## SYDNEY NORTH PLANNING PANEL

| <b>Panel Reference</b>   | 2018SNH043   |
| <b>DA Number</b>   | DA/668/2018  |
| <b>Proposed Development</b>  | Seniors living development comprising 146 independent living units and 74 residential aged care beds.  |

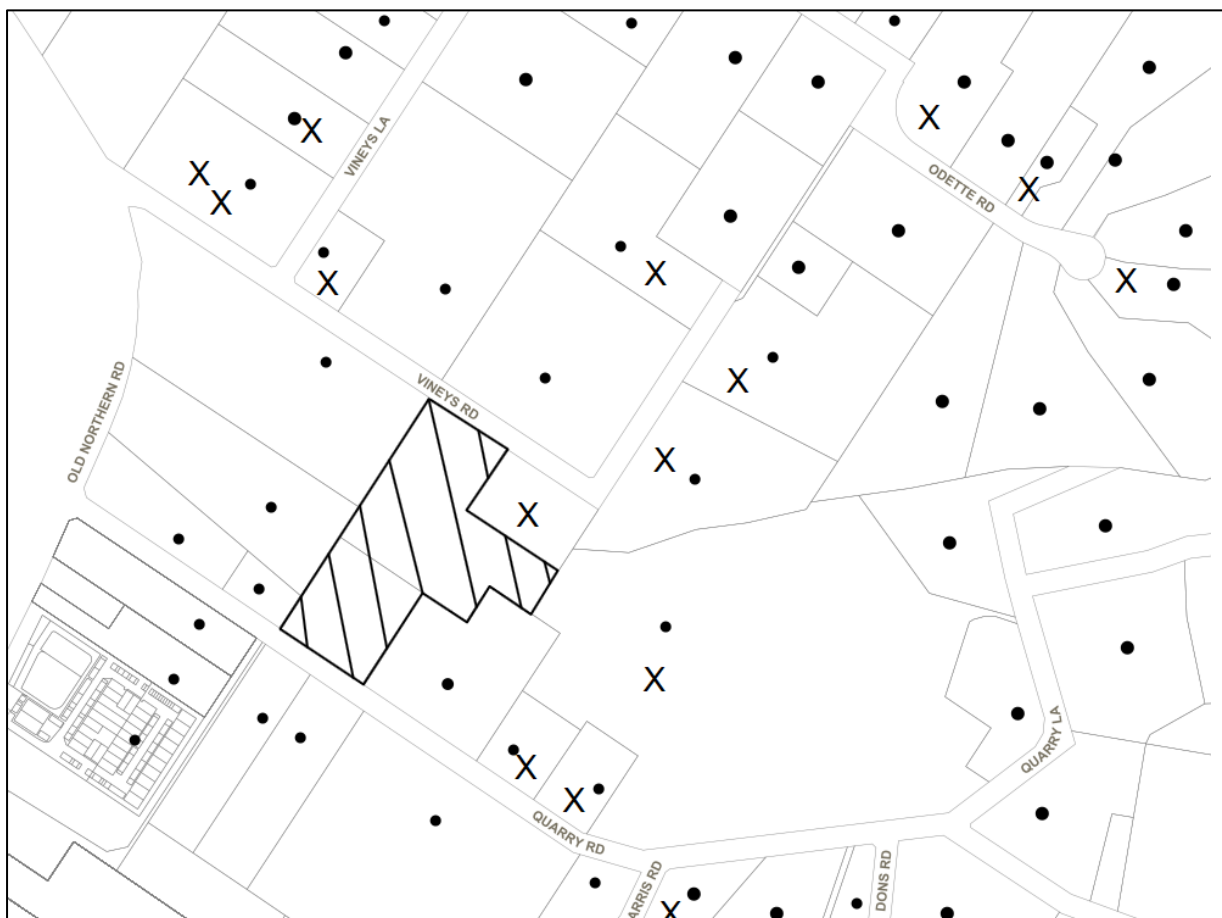
The development is partly mapped as bushfire prone land. In response to the bushfire hazard the site is proposed to be managed as an APZ which as a consequence limits the range of landscape that can be established due to the potential conflict with a sensitive seniors housing use on bushfire prone land.

In addition to the potential bushfire hazard, the site is traversed by a water course which should be rehabilitated as a riparian corridor. The current approach of imposing an urban typology on to the site has not appropriately balanced the consideration of the bushfire hazard, riparian corridor and rural landscaped character considerations. The proposed development is not suitable for the site.
